DOWNTOWN

Urban Alignment Characteristics

FIGURE 3-3 - STREET TYPOLOGIES

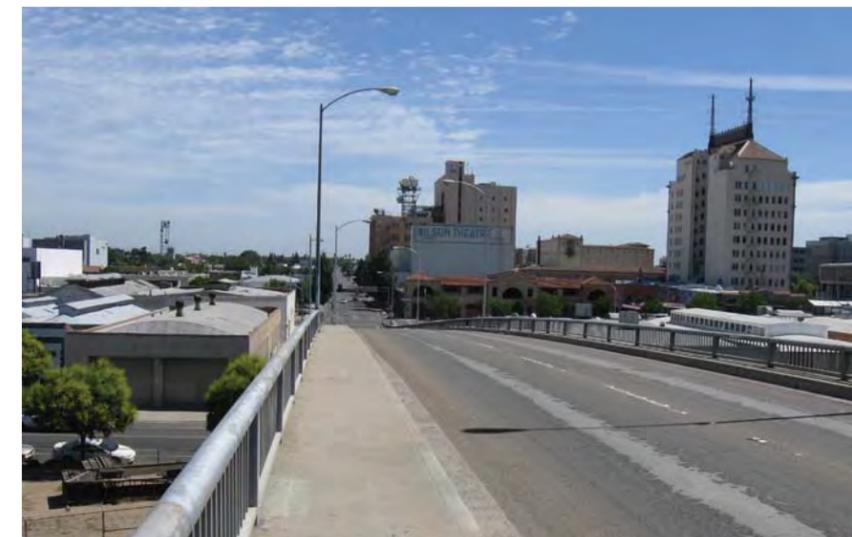
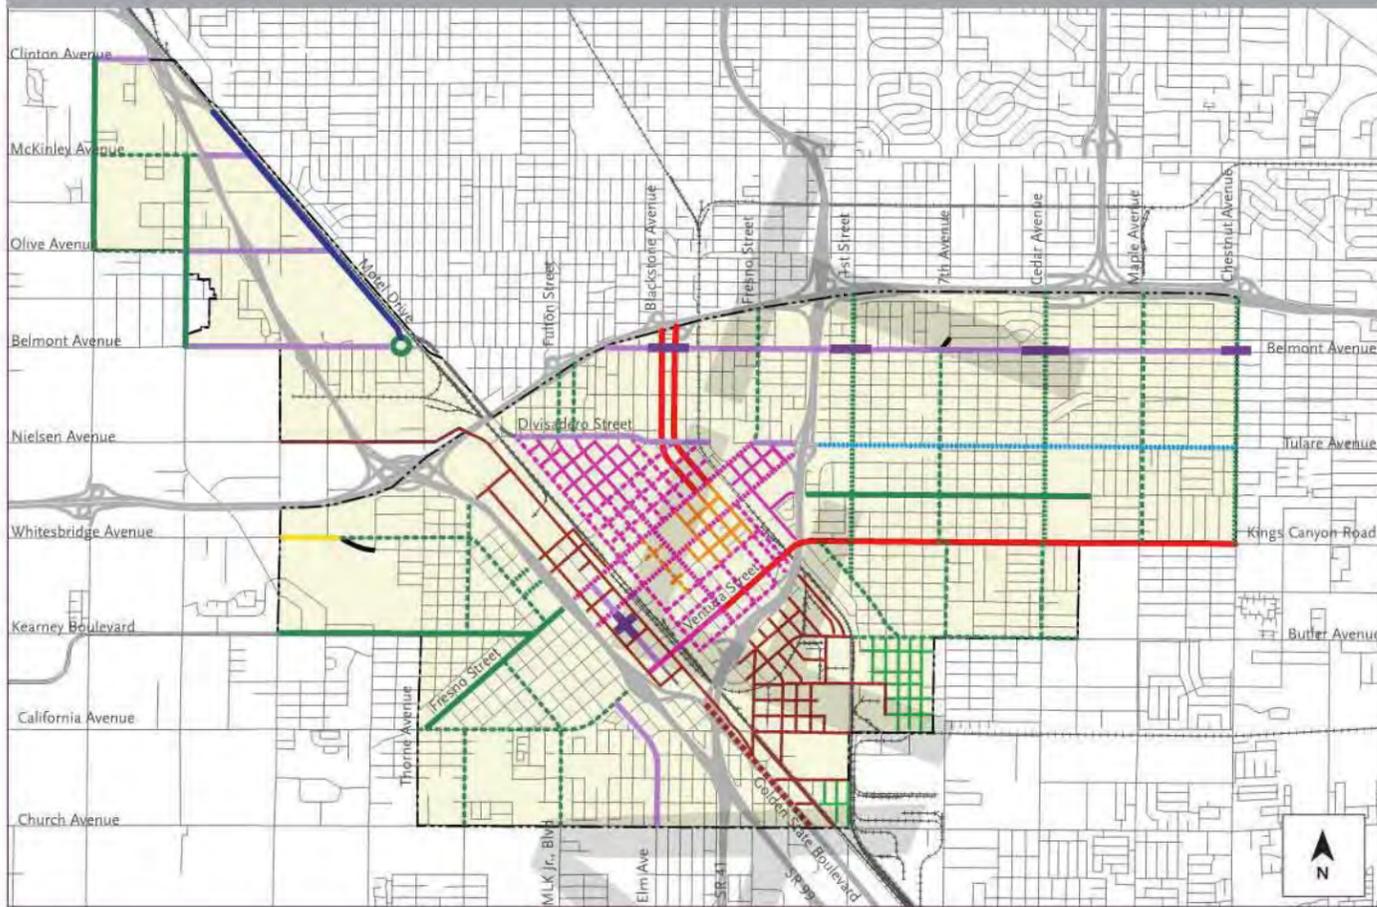
- **Each crossing section should be closely evaluated to accommodate all pedestrian and bicycle movements. It is important at under-crossing approach blocks that there is viable commercial frontage and pedestrian space at street level as well as an inviting pedestrian underpass. The crossing portions of these corridors should feel like a natural extension of the streetscape of downtown as envisioned in recent downtown plans.**

- **Most of the local street crossings over and under the HST corridor are high volume streets. Where possible, bike and pedestrian facilities on high-volume streets should be separated vertically and horizontally from auto lanes.**

- **At-grade sidewalks flanking the undercrossing approach should be 12' minimum on both sides to accommodate normal pedestrian circulation and street furnishings. For the underpass sidewalk, 14' minimum (16' preferred) should be provide as a shared facility. This profile can have grade that meets ADA criteria and be set higher than roadway profile at the bottom of underpass since its clearance requirements are considerably less than that for the vehicular travel lanes.**

- **All engineering profiles for proposed over-crossings and undercrossings, should be refined to minimize the length of sloped transition so that no more commercial frontage is affected by the dropping/rising grades than necessary**
